HISTORIC AND DESIGN REVIEW COMMISSION

August 02, 2017

HDRC CASE NO: 2017-359
ADDRESS: 630 MISSION ST
LEGAL DESCRIPTION: NCB 2913 BLK 2 LOT 8
ZONING: RM-4 , H
CITY COUNCIL DIST.: 1
DISTRICT: King William Historic District
APPLICANT: Jennifer Morey
OWNER: Jennifer Morey
TYPE OF WORK: Roofing material change, exterior modifications, rear window replacement
REQUEST:

Existing Site Plan

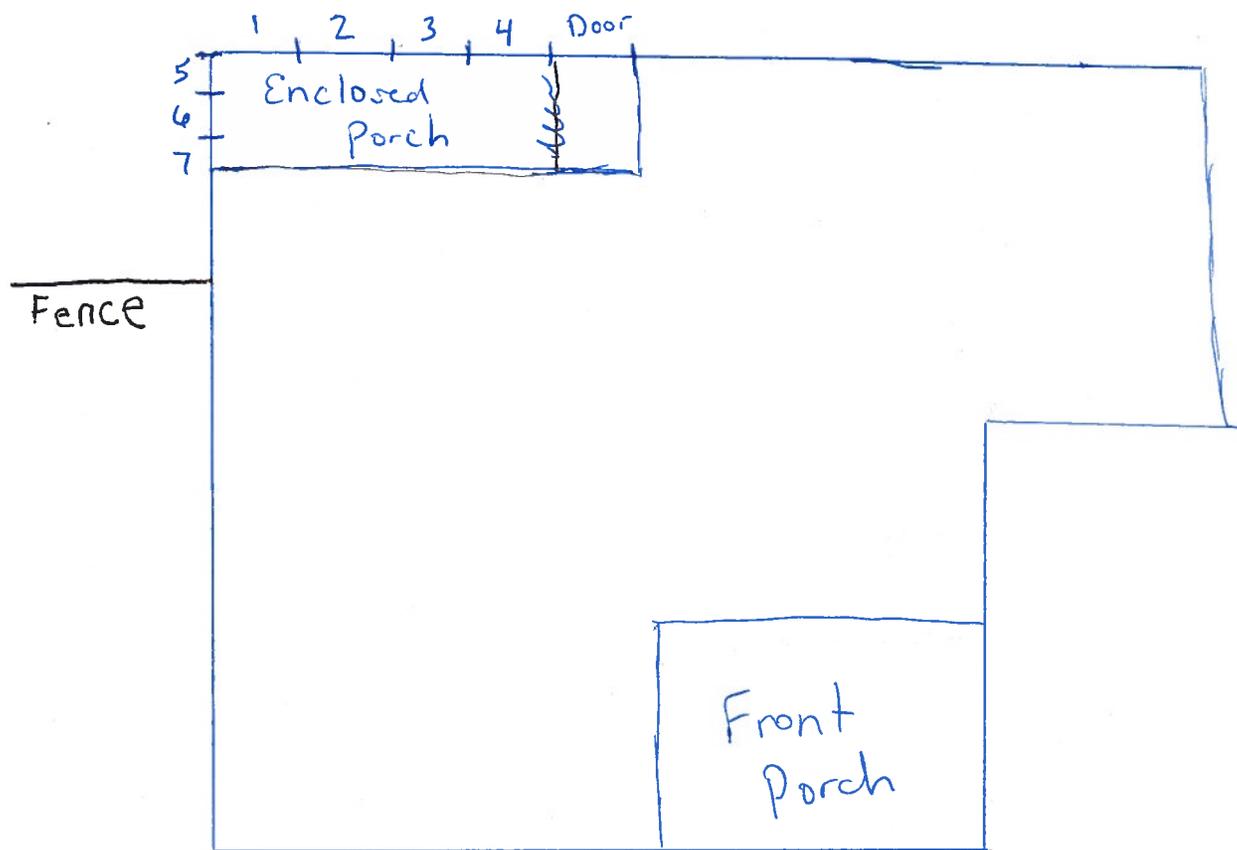
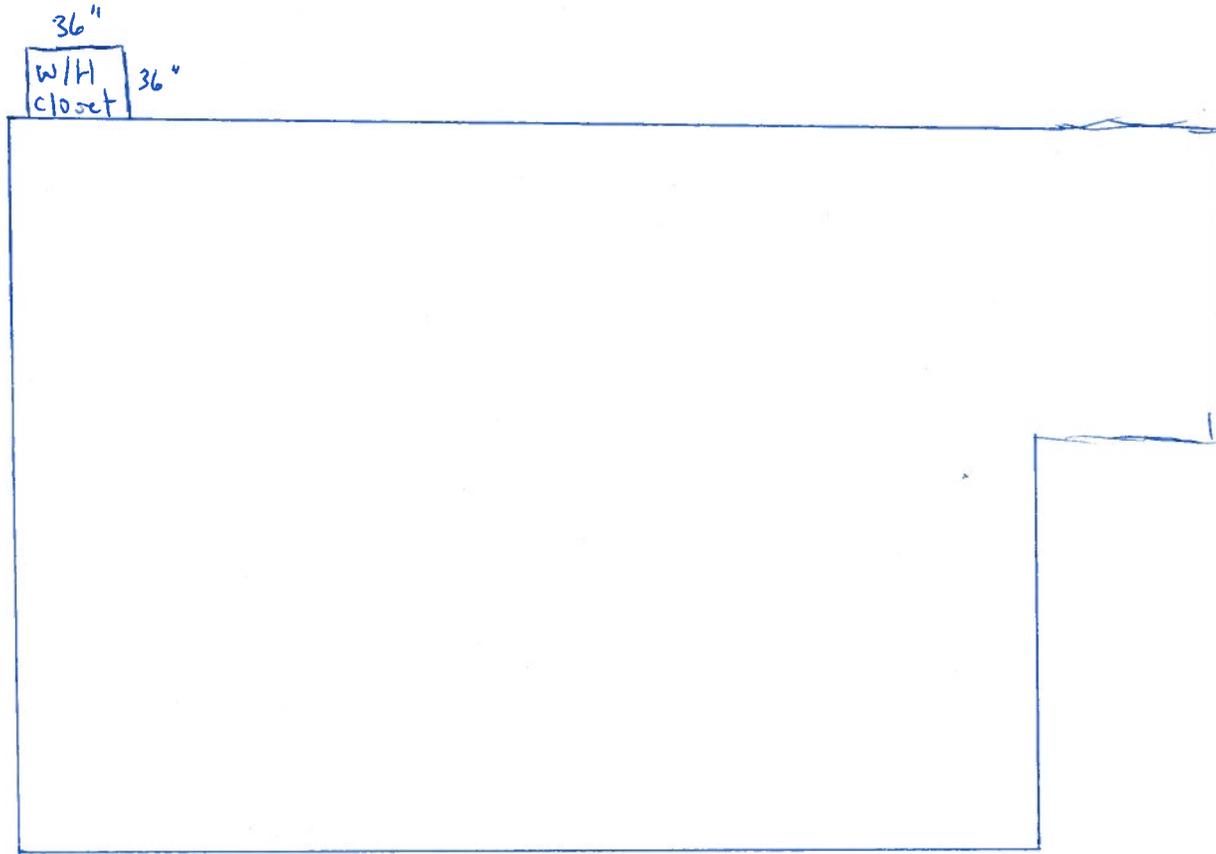
- c. **PORCH ENCLOSURE** – The rear porch is historic to the structure and as currently modified, the façade represents the openness of an enclosed porch. The applicant has proposed to remove the ganged window openings and install two windows to feature a width of forty inches and a height of twenty-four inches. Per the Guidelines for Exterior Maintenance and Alterations 7.B.ii. applicants should refrain from enclosing side and rear porches, particularly when connected to the main porch or balcony. Original architectural details should not be obscured by any screening or enclosure materials. Alterations to side and rear porches should result in a space that functions, and is visually interpreted as, a porch. Staff finds that the proposed rear modifications would result in a façade that no longer reads as a rear porch.

Staff does not recommend approval of item #2, the modification of the side and rear of the historic structure by enclosing seven window openings currently in an enclosed, original porch.
